Product Change Notice (PCN)

PCN Number: **PCN-0331031R-02**

Product(s) Affected: **CMM-3526AB-38308-TR**

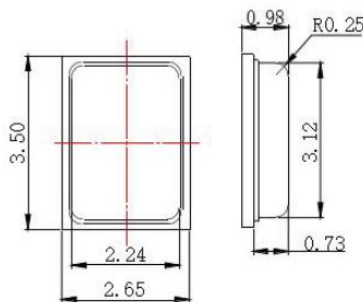
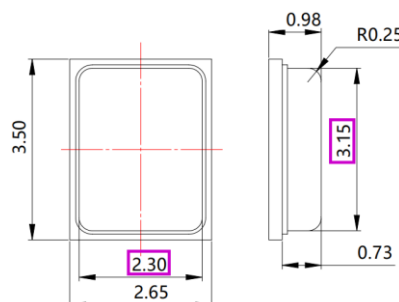
Description of Change: **current consumption increased to 155 μ A, signal to noise ratio reduced to 64dB(A) & acoustic overload point increased to 128 dB SPL. Back plate increased as shown in drawing below.**
